Customs Convention on the International Transport of Goods under Cover of TIR Carnets (TIR Convention, 1975):

Amendment proposals for the Convention: vehicles with sliding sheets

Comments on revised amendment proposals to Annexes 2 and 7 of the Convention

Submitted by the International Association of the Body and Trailer Building Industry (CLCCR)

Sketch No. 9.4

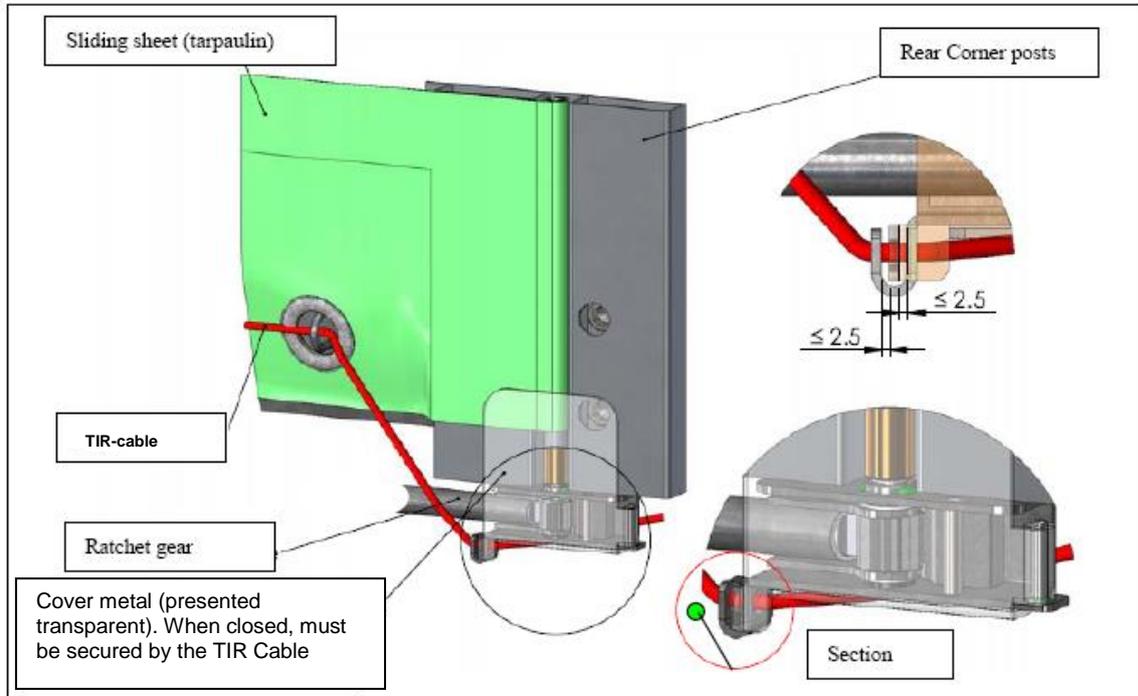
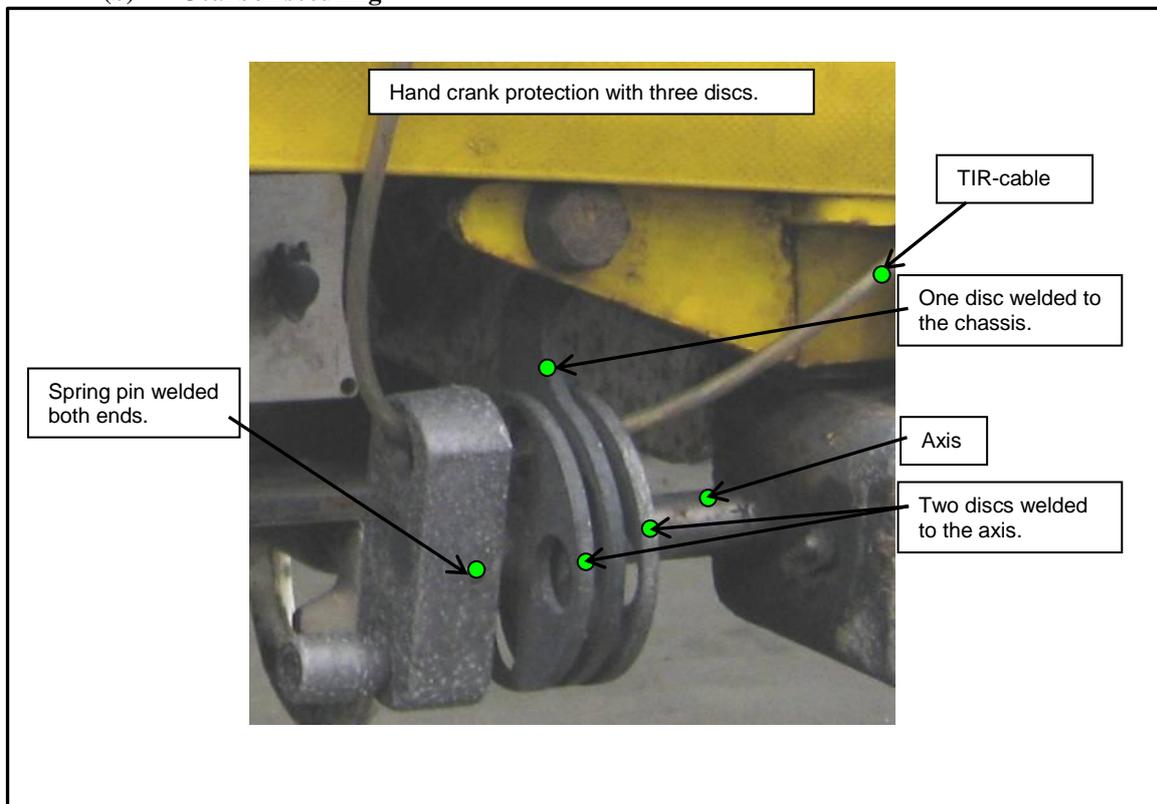
6. Amend Sketch No. 9 as follows:

To tighten the sliding sheets in the horizontal direction, a ratchet gear is used (normally on the rear end of the vehicle). This sketch shows two examples (a) and (b) how the ratchet or gearbox may be secured.

Sketch No. 9.5

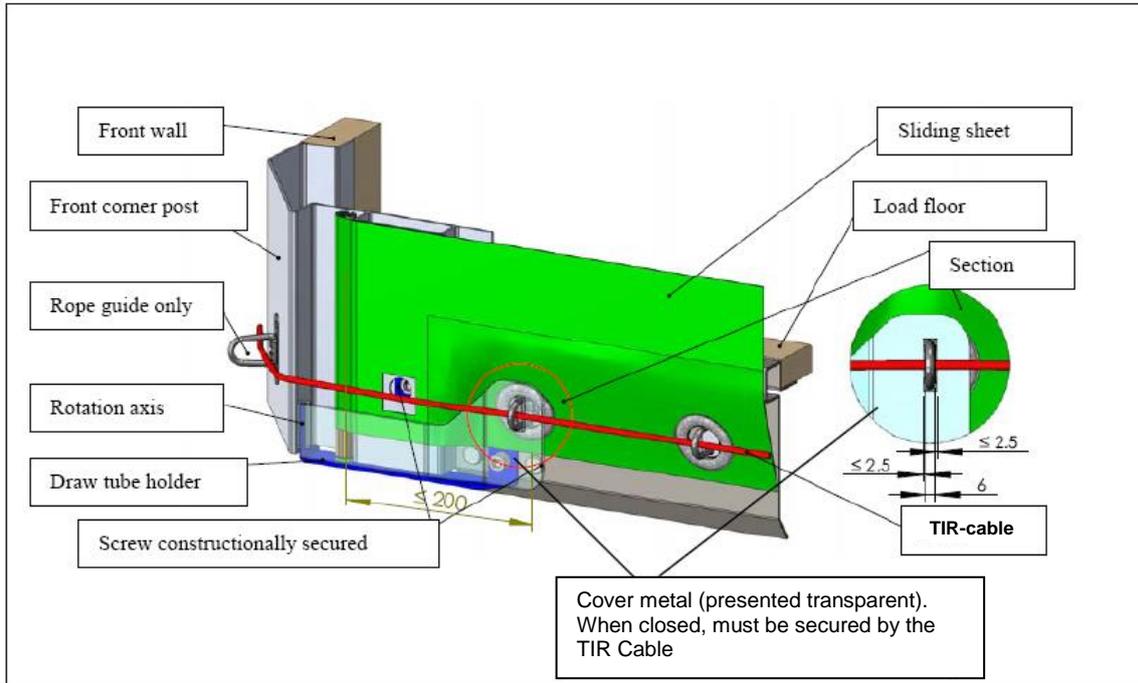
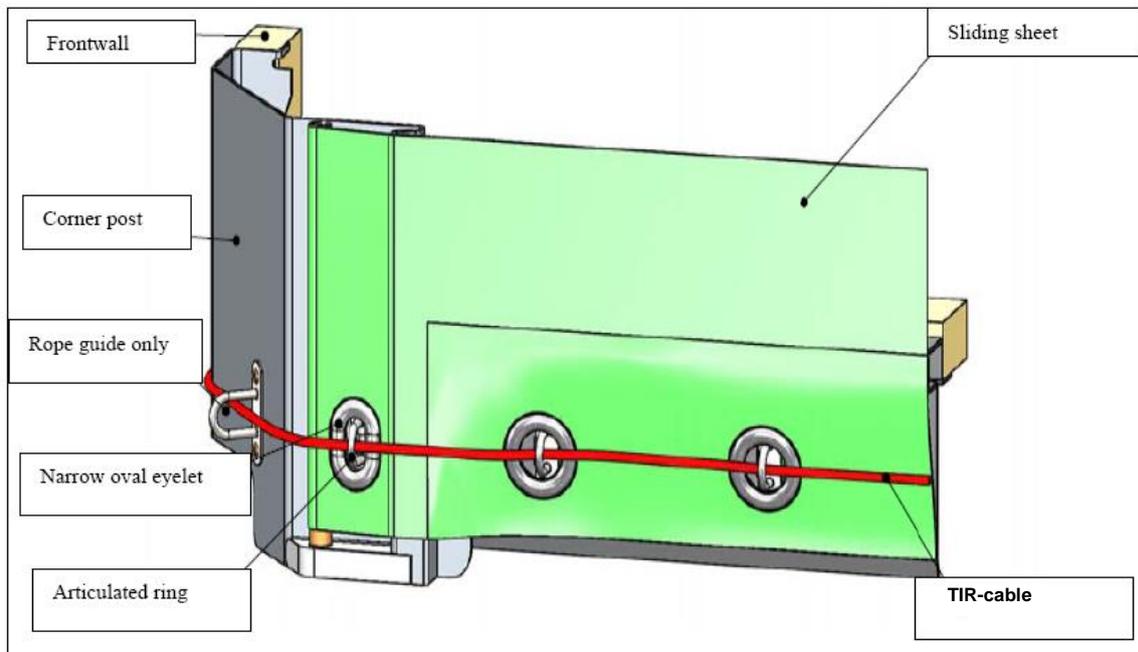
To fix the tarpaulin on the other side (normally to the front of the vehicle) the following systems (a) or (b) may be used.

Sketch No. 10

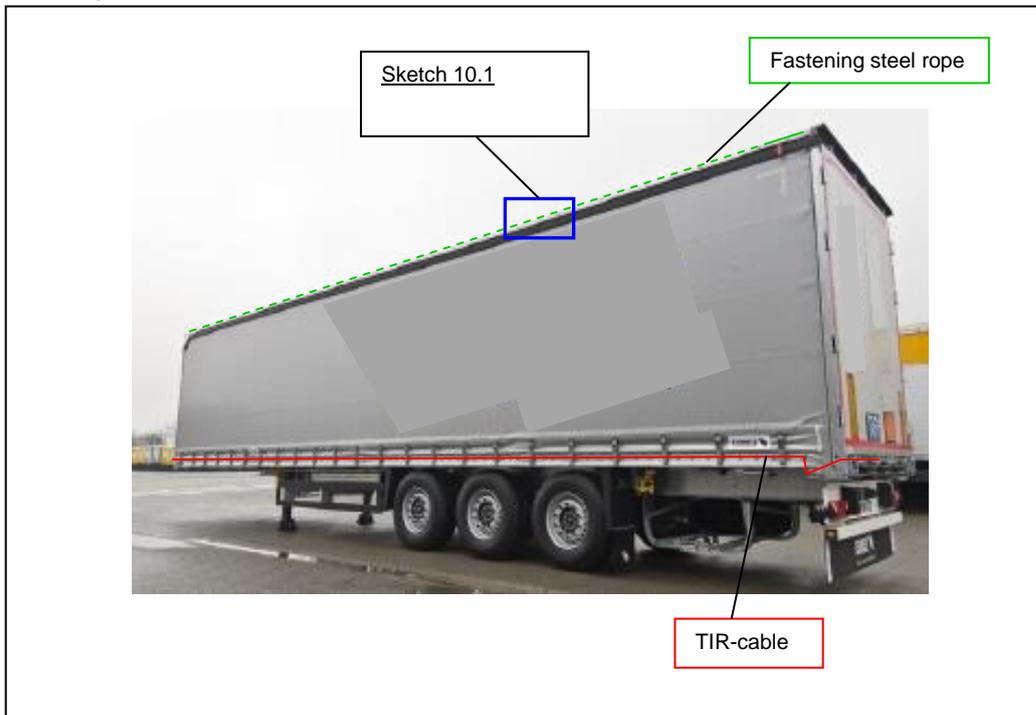
7. After Sketch No. 9, add a new Sketch No. 10:

This sketch shows an example of a vehicle and of important points described within Annex 2, Article 5.

Sketch No. 10.1

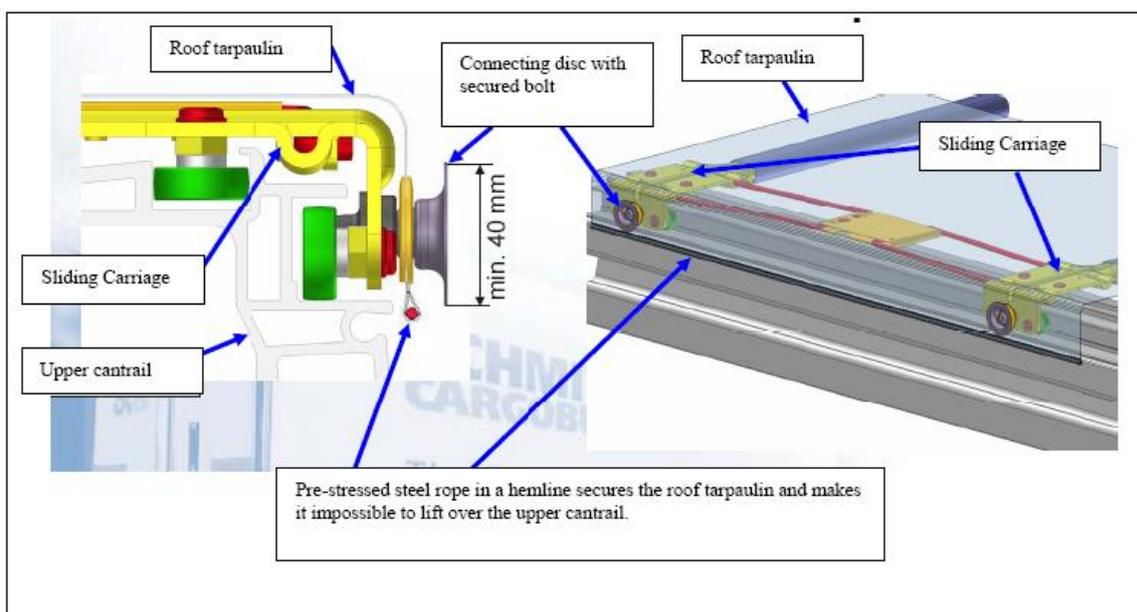
The Customs security of the sliding roof is guaranteed if a pre-stressed **fastening** steel rope, embedded in a hemline, is fixed. This steel rope is fixed to the front and rear of the **body container**. The tractive force as well as the connecting disc on each sliding carriage, makes it impossible to lift up the hemline with the steel rope above the upper cantrail.

Sketch No. 9.4

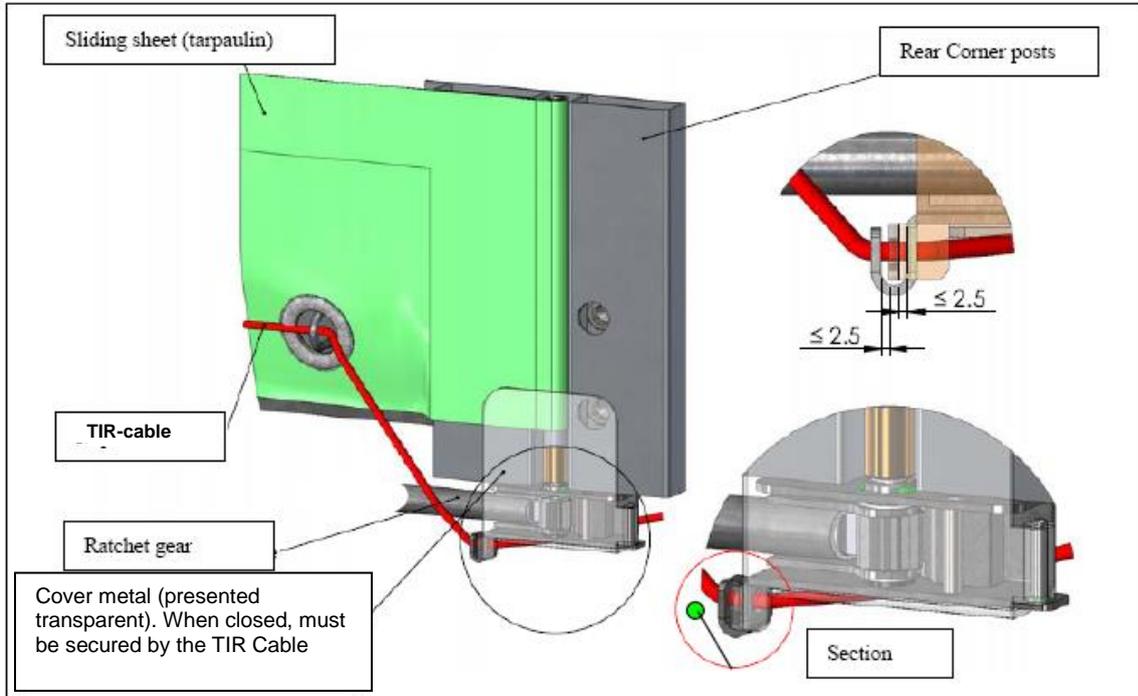
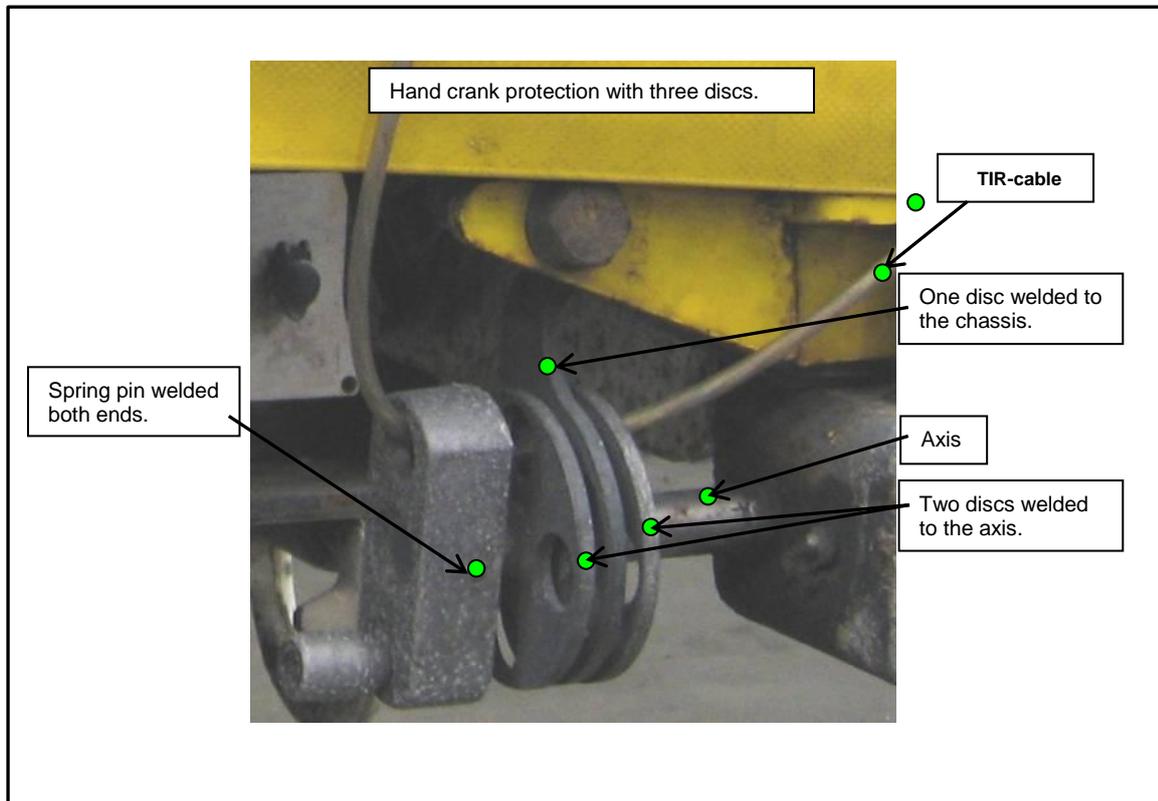
11. Amend Sketch No. 9 to Annex 7 –Part I,

To tighten the sliding sheets in the horizontal direction, a ratchet gear is used (normally on the rear end of the **vehicle container**). This sketch shows two examples (a) and (b) of how the ratchet or gearbox may be secured.

Sketch No. 9.5

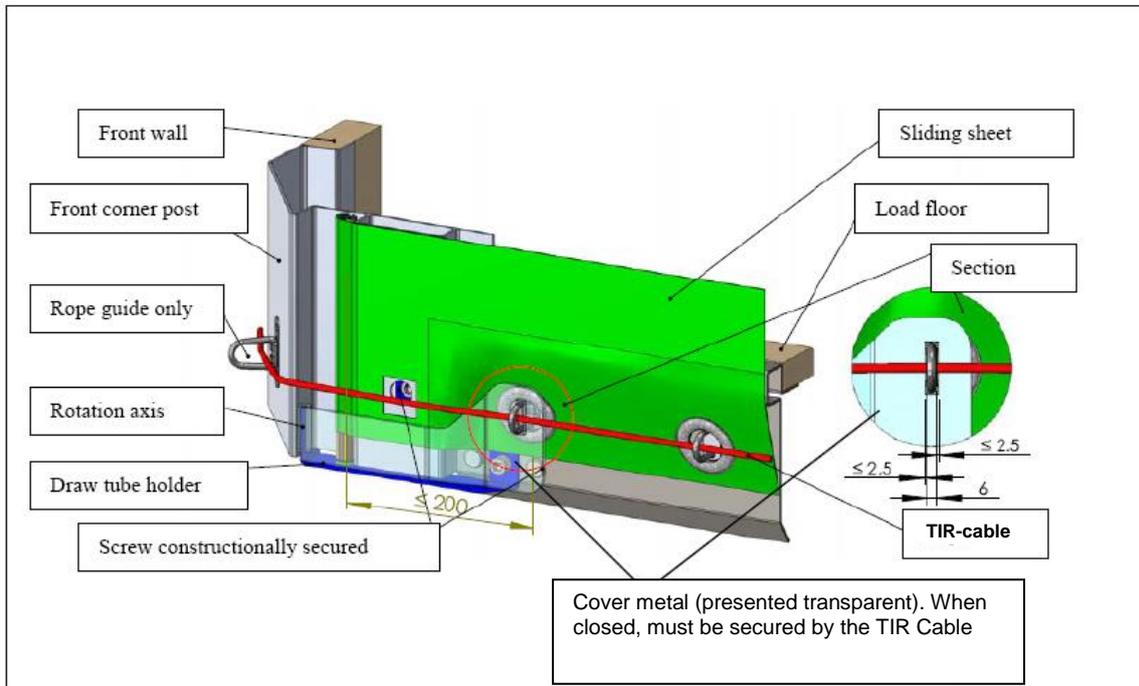
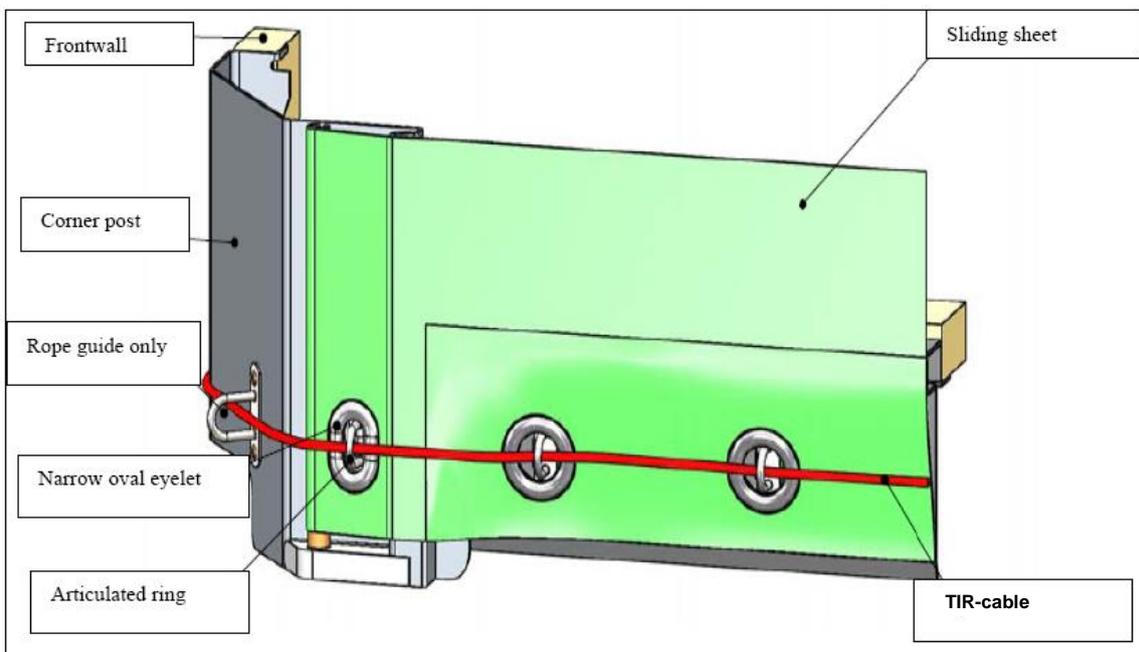
To fix the tarpaulin on the other side (normally to the front of the container) the following systems (a) or (b) may be used.

Sketch No. 10

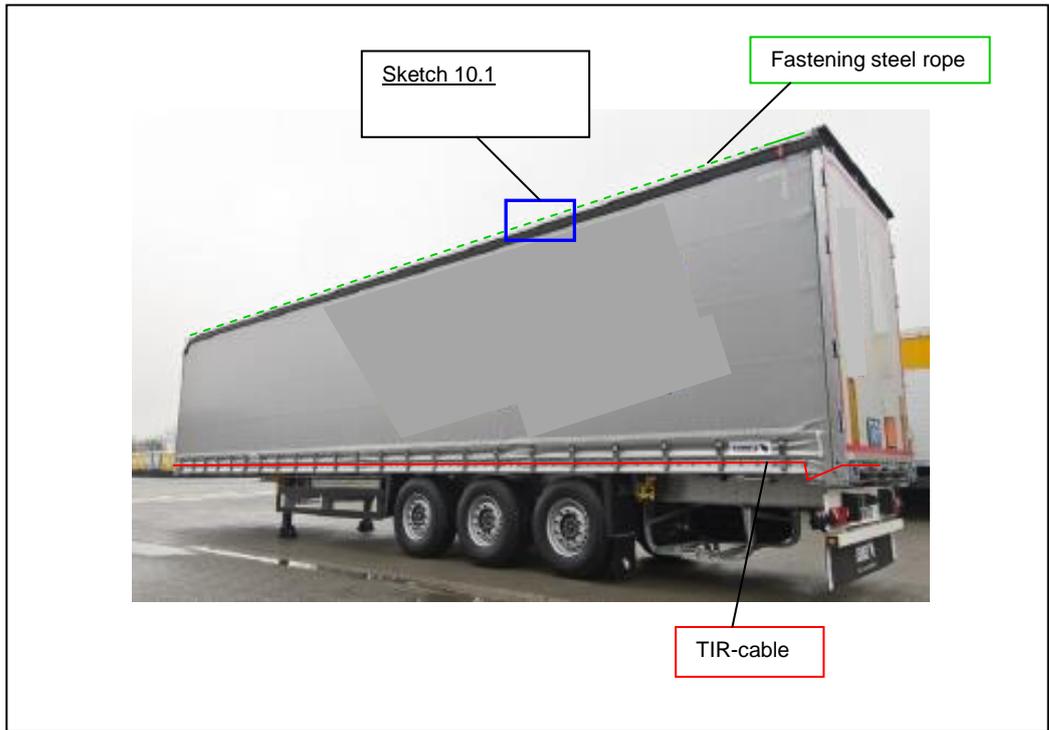
12. After Sketch No. 9 add a new Sketch No. 10:

This sketch shows an example of a container and of important points described within Annex 2, Article 5.

Sketch No. 10.1

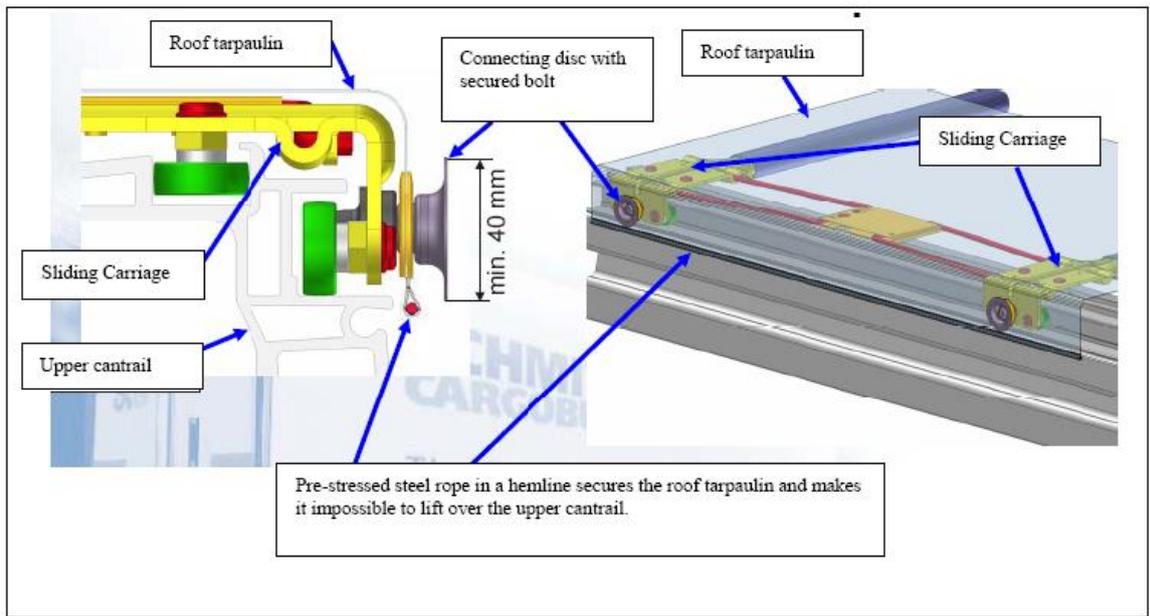
The Customs security of the sliding roof is guaranteed if a pre-stressed **fastening** steel rope, embedded in a hemline, is fixed. This steel rope is fixed to the front and rear of the container. The tractive force as well as the connecting disc on each sliding carriage, makes it impossible to lift up the hemline with the steel rope above the upper cantrail.
